5.3 NO. 50 (LOT: 412 D/P: 415381) BARLEE STREET, MOUNT LAWLEY - PROPOSED SINGLE HOUSE S.31 RECONSIDERATION

TRIM Ref: D21/1357

Author: Dan McCluggage, Urban Planner

To reconsider an application for development approval at the invitation of the State Administration Tribunal (SAT) for a Single House at No. 50 Barlee Street, Mount Lawley (the subject site).

JOB No. 20-006	DWG TITLE ELEVATIONS 1 & 2	SCALE 1:100	DATE: 21/01/2021	PAGE: 5 OF 13
CLIENT DAVOR NIKOLIC		PROJECT ADDRESS Lot 412, Barlee St, MOUNT LAWLEY

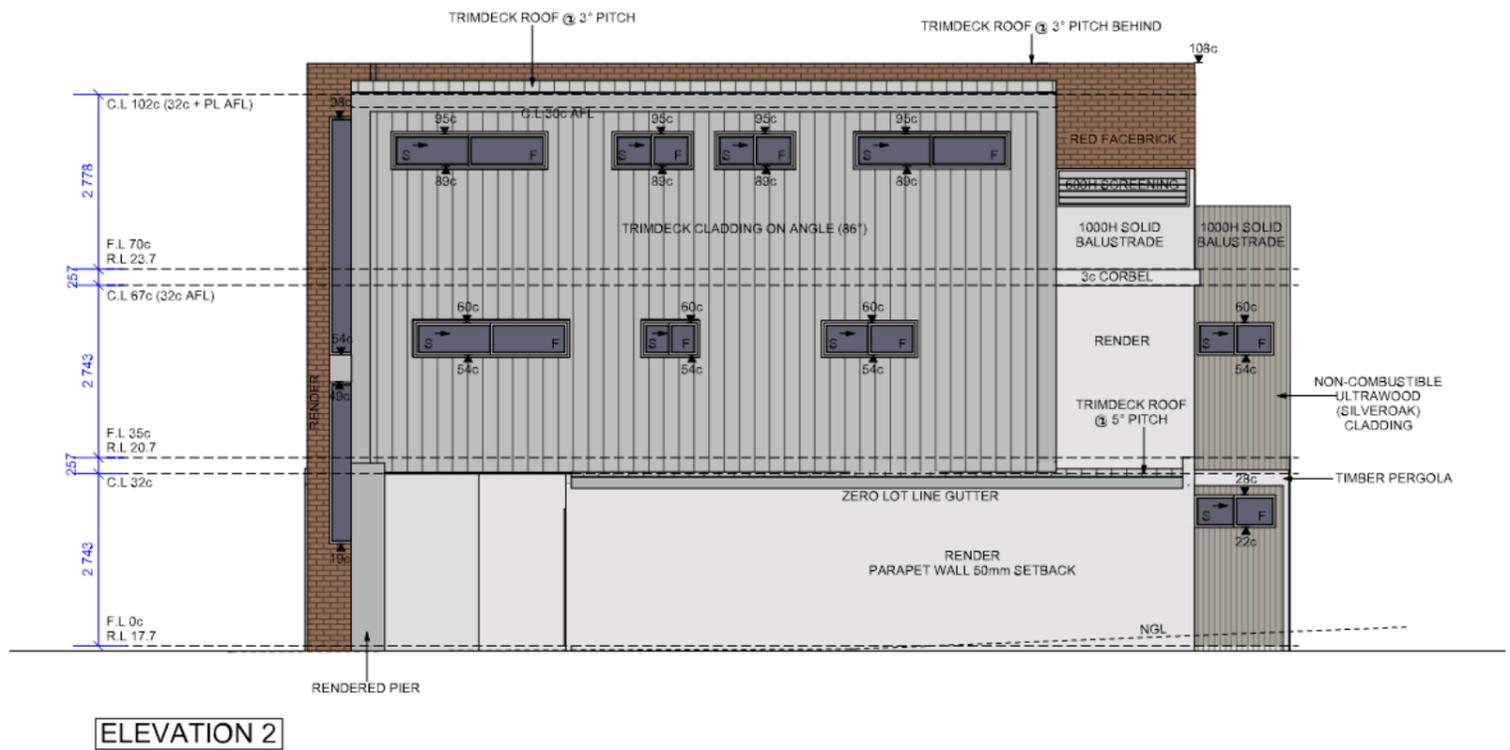
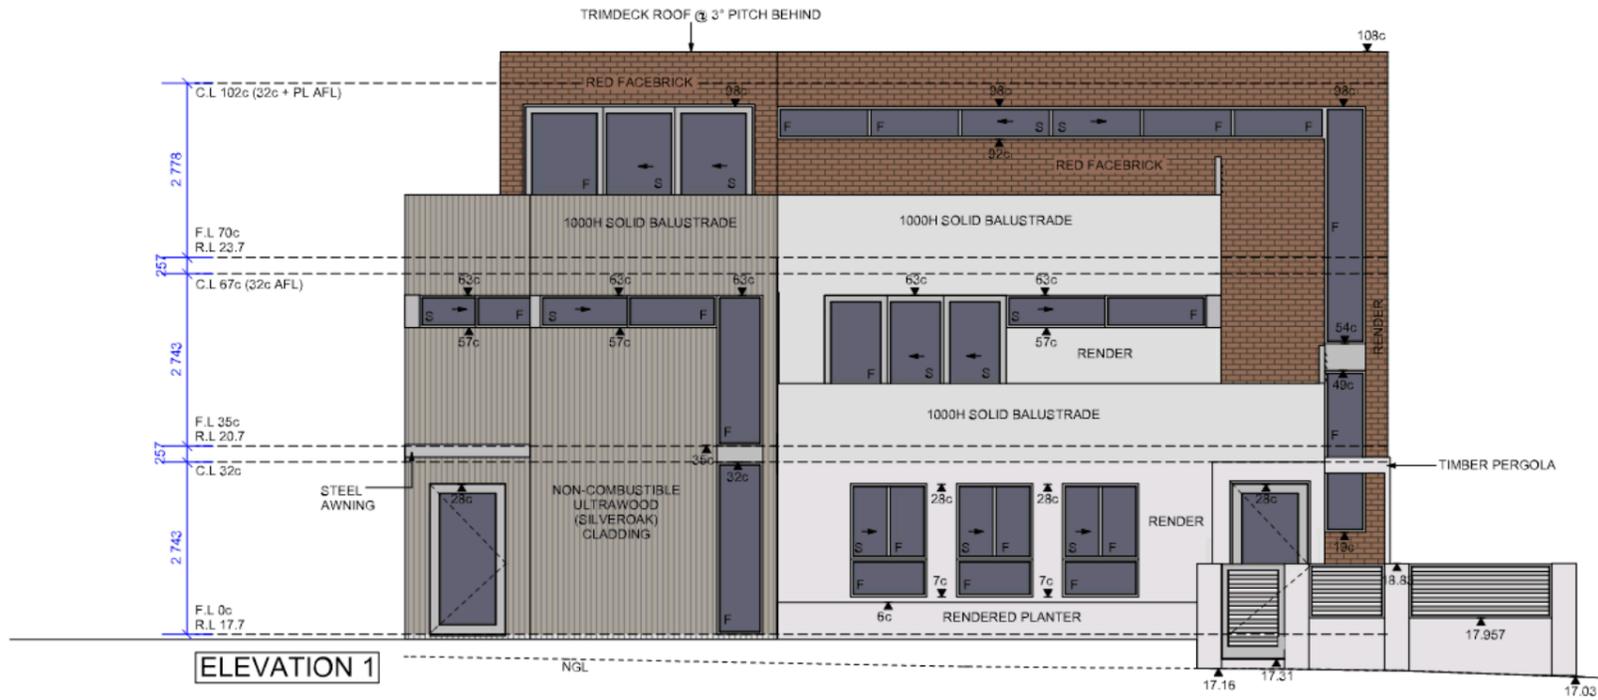
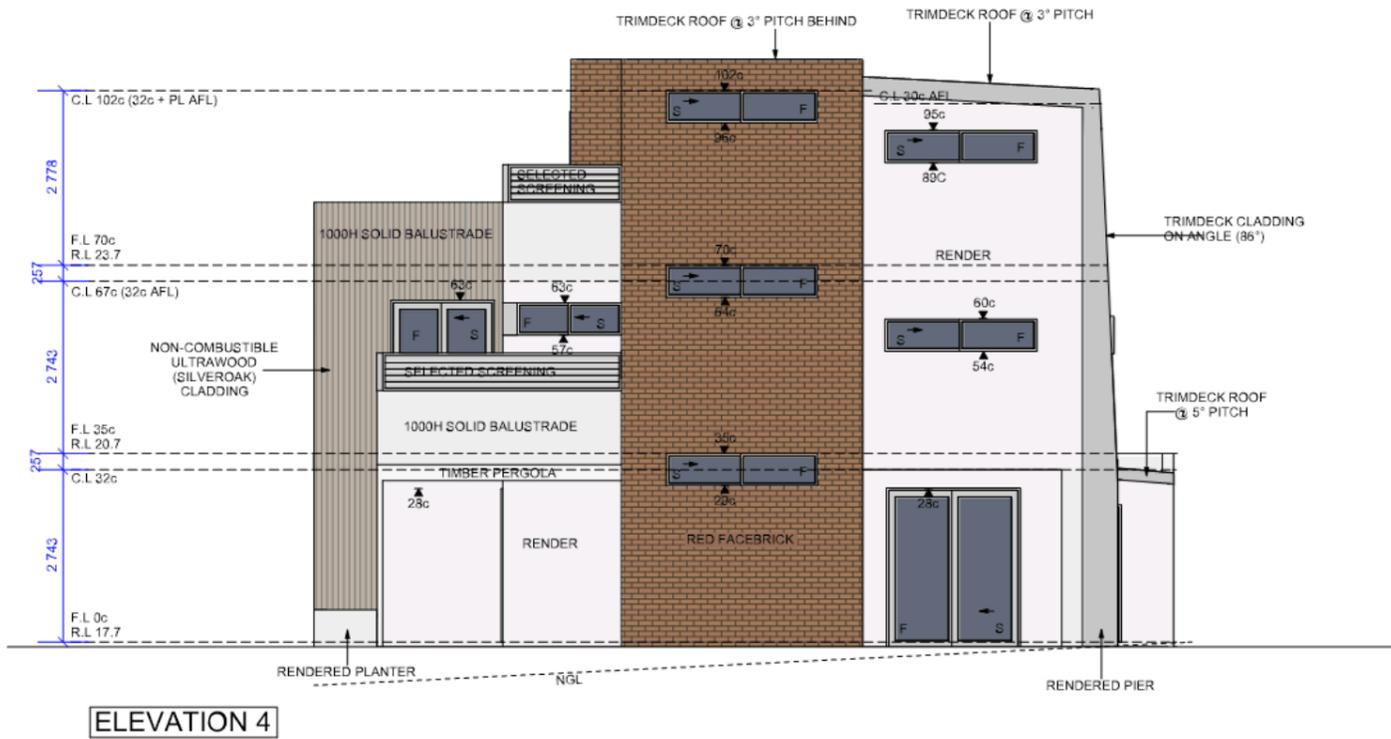
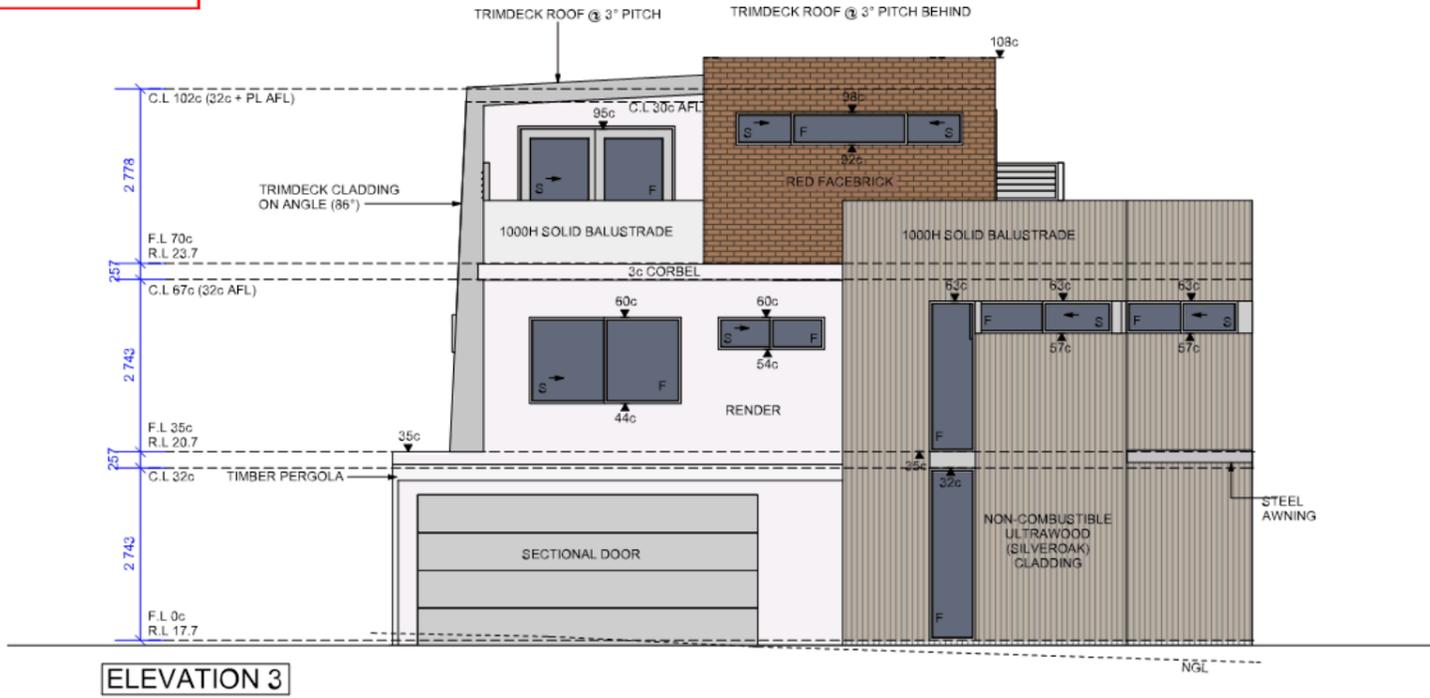
Whilst the building height of the current proposal exceeds the deemed-to-comply standards of the Built Form Policy, the design has been amended to remove the cantilevered upper floor balcony, providing staggered street setbacks with the upper floors setback behind the predominant building line of the ground floor. The amended approach to arrangement of building massing with increased upper floor setbacks result in a development outcome which would be compatible with the adjacent heritage listed building with regard to building height and effectively addresses the previous reason for refusal.

- The development would provide an appropriate transition between the six storey mixed use development to the north west and single houses to the south east in relation to building height as well as roof form;

JOB No. 20-006	DWG TITLE GROUND FLOOR LANDSCAPING	SCALE 1:100	DATE: 21/01/2021	PAGE: 7 OF 13
CLIENT DAVOR NIKOLIC	PROJECT ADDRESS Lot 412, Barlee St, MOUNT LAWLEY

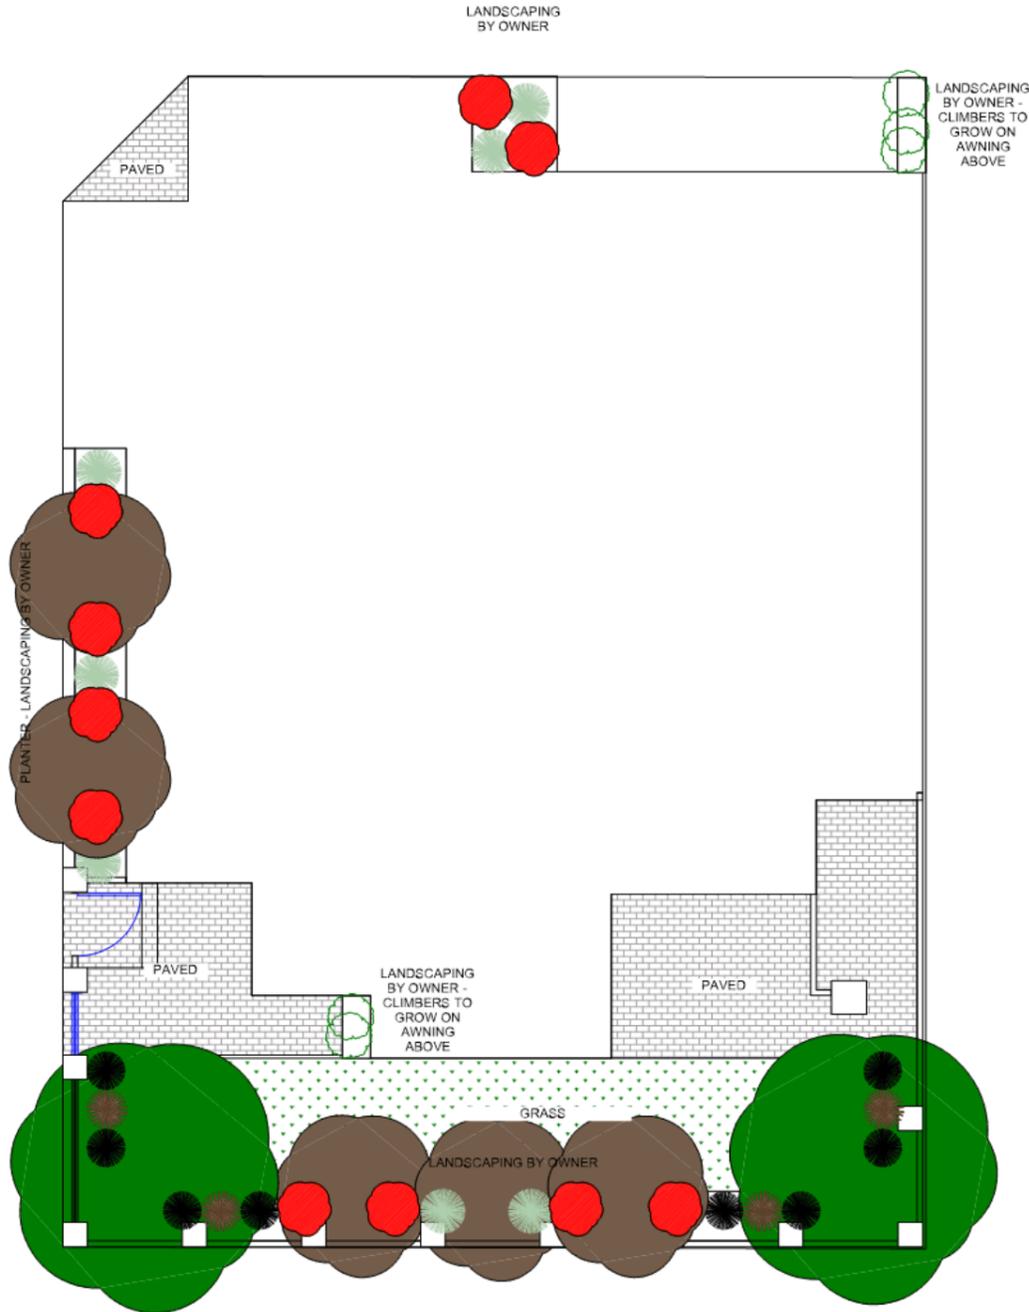
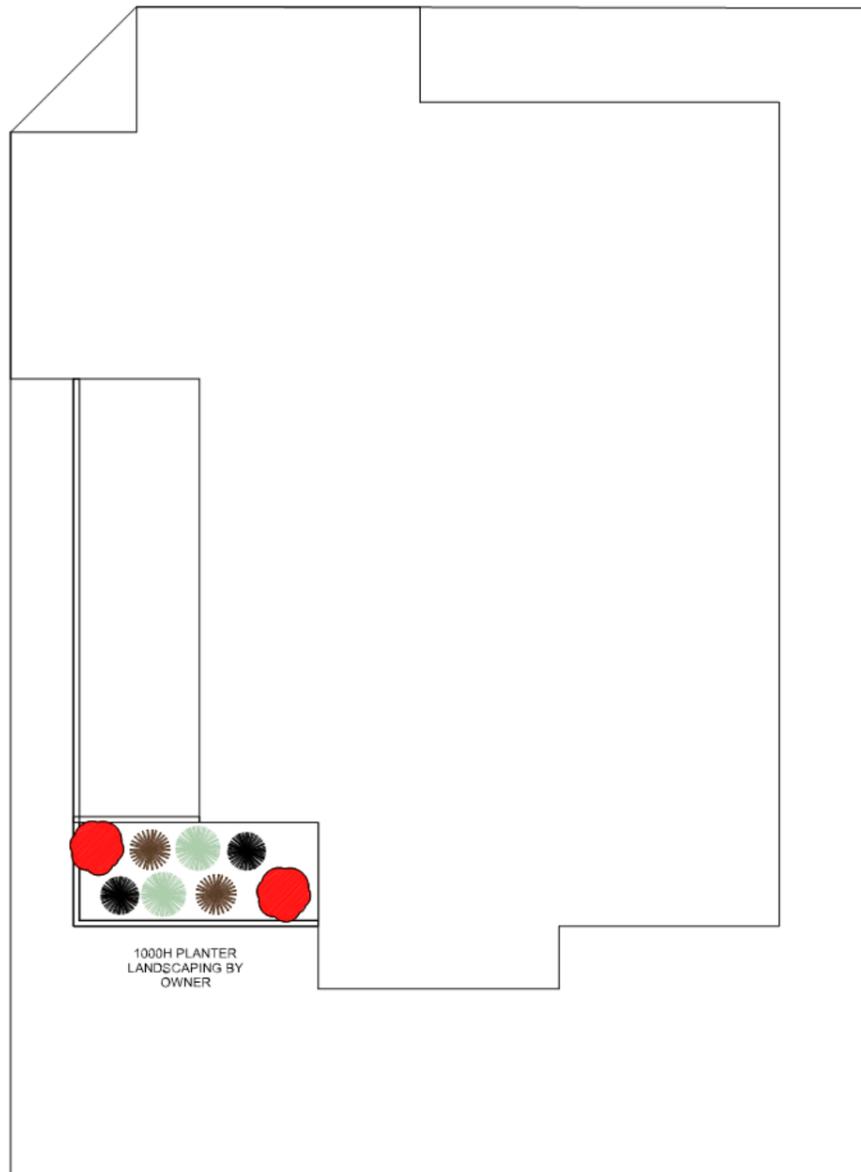
The Built Form Policy requires 12 percent of the site provided as deep soil zones, 3 percent of the site provided as planting areas and 30 percent of the site provided as canopy coverage at maturity. The application proposes 15.7 percent deep soil zones, 2.4 percent planting areas and 19.2 percent canopy coverage at maturity.

The previously refused plans provided 11.5 percent deep soil zones and 13.8 percent canopy coverage at maturity. Reason 4 for refusal of the previous proposal outlined that the development would not provide for adequate landscaping on site and would not result in a high quality landscaping outcome.

- The desirable proposed nil setbacks to Barlee Street and Kaata Lane limit opportunities to provide canopy coverage within street setback areas. The proposed built form outcome with reduced street setbacks would be appropriate in the context of the site's location adjacent to the town centre and a six storey mixed use development to the north west, 'stepping back' to provide a transition to the Residential R50 zoned lot to the south east of the site. Trees have been provided on the ground floor in these sections of 'stepping back' within portions of the primary street setback area and the interface between the proposed dwelling and the adjoining property to the south east that would effectively contribute towards canopy cover visible from Barlee Street and adjoining properties;

- The application proposes on-structure landscaping on the first and second storeys of the building that are capable of supporting plantings and shrubs that would assist in softening the appearance of the dwelling. A condition of approval has been recommended that requires the selection of planting species in order to achieve this outcome, such as a trailing or climbing species;

- Planters on the ground floor area and second floor terrace which cannot be included in the technical assessment because they have a width less than 1 metre would accommodate small plants and shrubs, further contributing to the overall landscaping outcome;

- Further to the 19.2 percent canopy at maturity that would be provided on site, the development would contribute towards additional canopy coverage that falls outside of the lot boundaries. Inclusive of the canopy that falls outside the lot boundaries, the development would provide 28.4 percent of the site area as mature canopy;

7.1 A detailed landscape and reticulation plan for the development site and adjoining road verge, to the satisfaction of the City, shall be lodged with and approved by the City prior to lodgement of a Building Permit. The plan shall be drawn to a scale of 1:100 and show the following:

- The location and type of existing and proposed trees and plants;
- Areas to be irrigated or reticulated;
- The provision of a minimum of 12 percent deep soil area, 3 percent planting areas and 19.2 percent canopy cover at maturity, as defined by the City's Policy No. 7.1.1 – Built Form;

- The provision of plantings within the planter areas located on the first and second floors of the dwelling that would be visible from Barlee Street, such as trailing or climbing species. The species shall be to the City's satisfaction; and

- The provision of trees contributing towards canopy coverage within deep soil areas provided and within the front setback area. The tree species are to be in accordance with the City's recommended tree species list;
